July 27, 2017

Subject: **URGENT MEDICAL DEVICE CORRECTION**

Affected Product: A.T.S® 2200TS and A.T.S® 4000TS

Zimmer Biomet Surgical is initiating a Medical Device Correction for the A.T.S® 2200TS and A.T.S® 4000TS to provide an on-device label and 3 pages of an updated Operator/Service Manual.

Figure 1. Proper on-device label placement

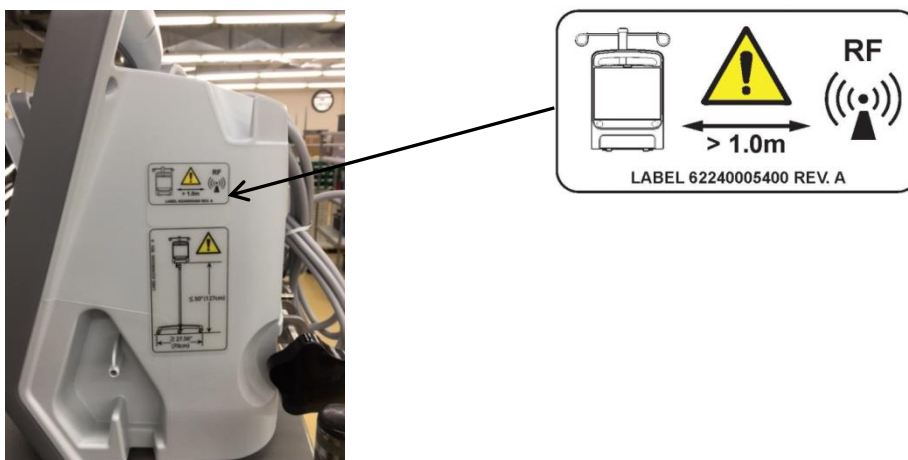
Zimmer Biomet is now communicating this newly shortened separation distance of 1.0m between RF communication equipment to mitigate the potential for electromagnetic interference and achieve optimal performance of the tourniquet machines. We are providing an on-device label and updated Operator/Service Manual pages to notify our customers of this newly established separation distance to allow for a smaller distance between equipment, suitable for smaller OR settings. The proper on-device label placement is to have the label placed directly above the IV Pole label on the side of the device, as shown below on Figure 1.

1. Review the notification and ensure affected personnel are aware of the contents.
2. Confirm that you have received the on-device label and 3 pages of the updated Operator/Service Manual, included in this package.
3. Place the label on the device in the location specified in Figure 1 above.
4. Replace the 3 pages of the Operator/Service Manual with the updated pages.
5. Email a completed copy of the Attachment 1 form to Corporatequality.postmarket@zimmerbiomet.com to confirm that you have placed the label in the specified location on the device and replaced the 3 pages of the Operator/Service Manual with the updated pages.
6. If after reviewing this notification you have further questions or concerns please call +1(330) 364-0989 between 8:00 am and 5:00 pm EST, or contact your Zimmer Biomet Sales Representative.
